CEMEX Lyons - Q2 2022 C-pit monitoring report

RE: Additional Information Request
Lyons Quarry, Permit No. M-1977-208
Y22Q2 Groundwater Monitoring Report, C-Pit

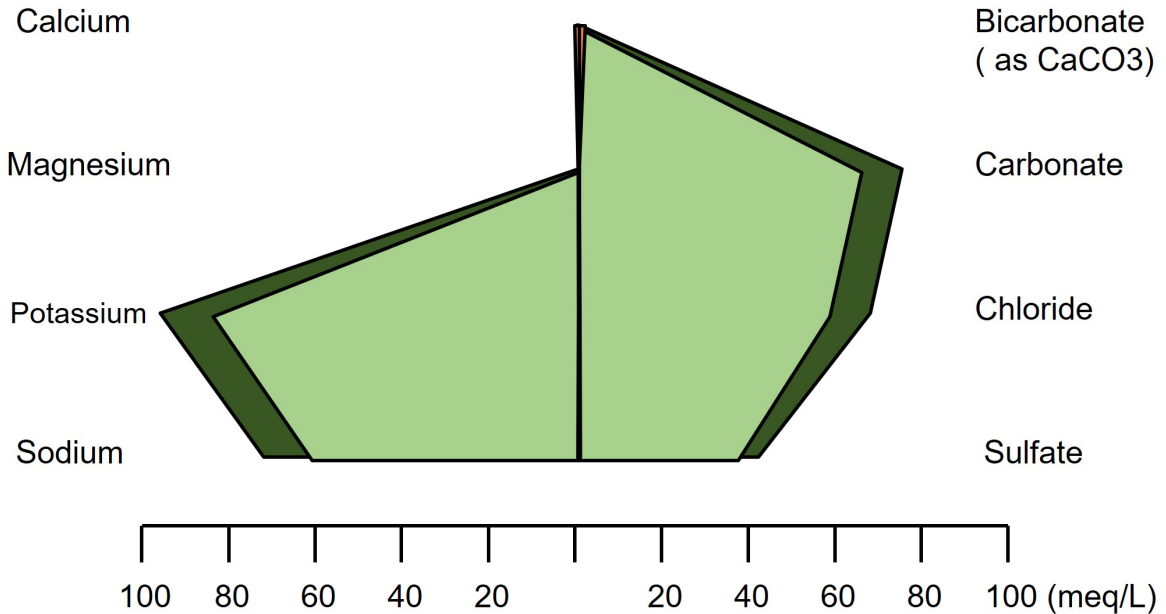
1. The Stiff Diagram appears to be missing data for CEM-004. If so, please revise the diagram with the new information and resubmit.

CEM-004 is plotted on the stiff diagram shown in Figure 1. The concentrations of the water sample collected from CEM-004 are much lower than those in C-Pit resulting in a thinner plot area for CEM-004. An image file "2022Q2_stiff.jpg" of the stiff diagram has been attached to allow the image to be enlarged for detailed viewing.

Figure A Time trend plots for CEM-001

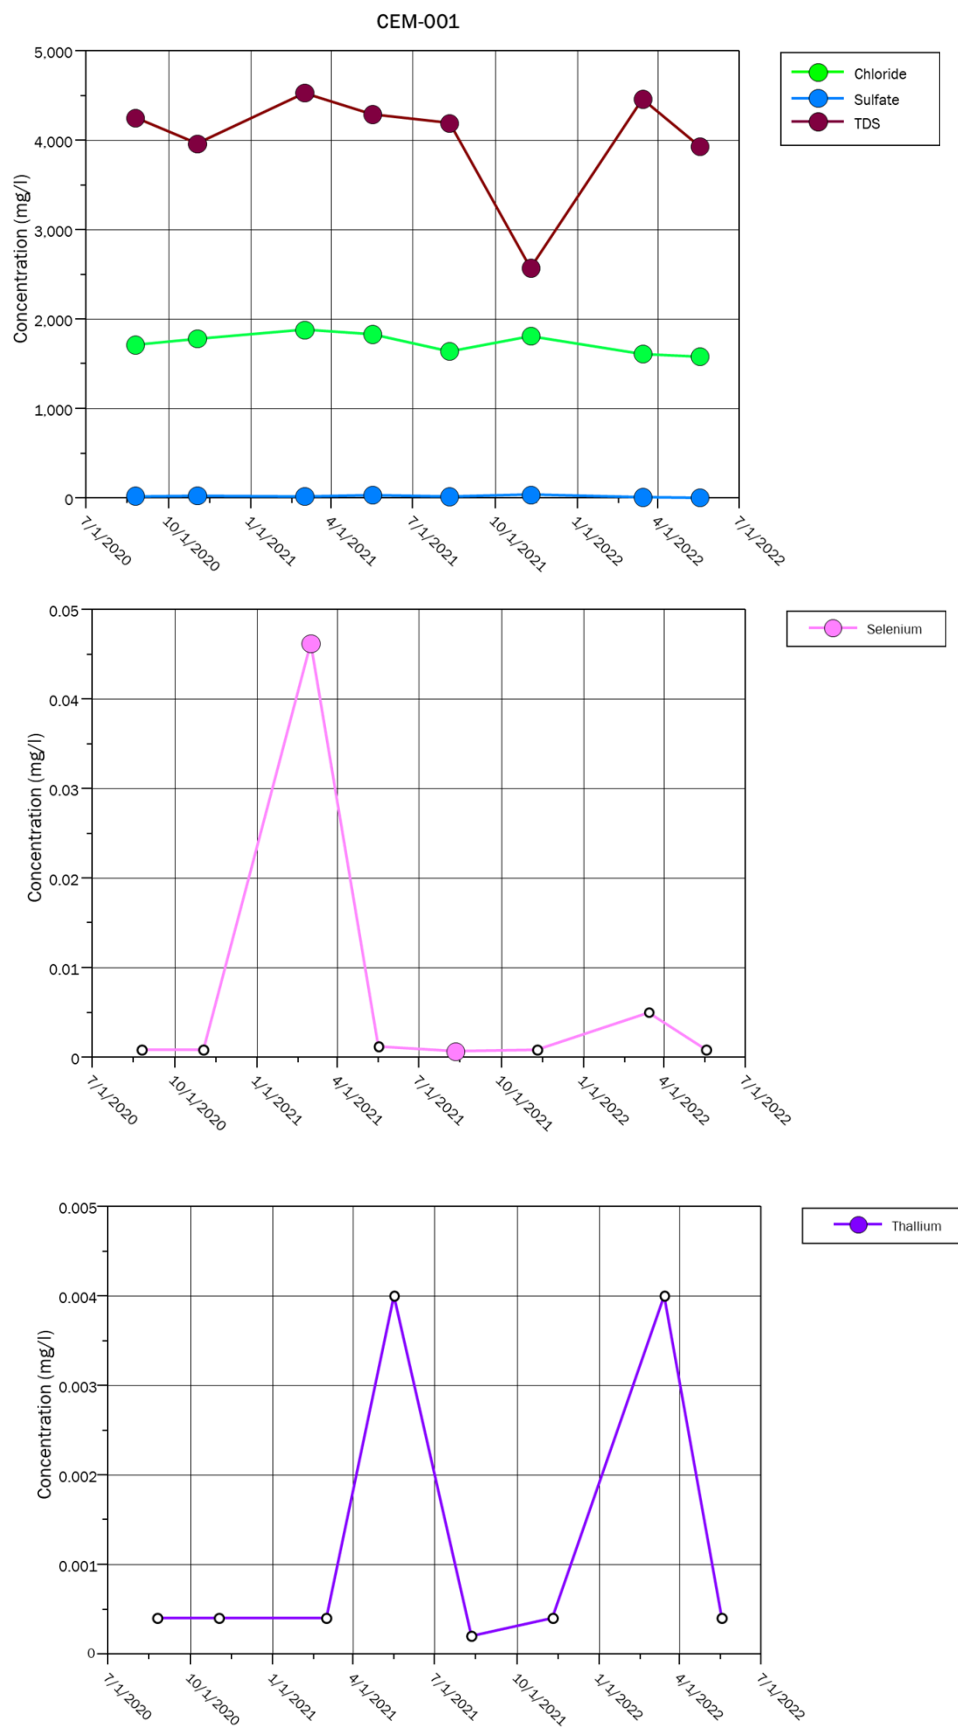
4. Please provide graphs for analyte concentrations for each location that depict trends over the last eight (8) quarters. Please included these graphs as part of future reports.

CEMEX has attached the requested graphs and will continue to submit the data for the last 8 quarters in future submittals. This attachment is titled "2022 Q2_CEMEX plots_8-qrtr history.pdf"
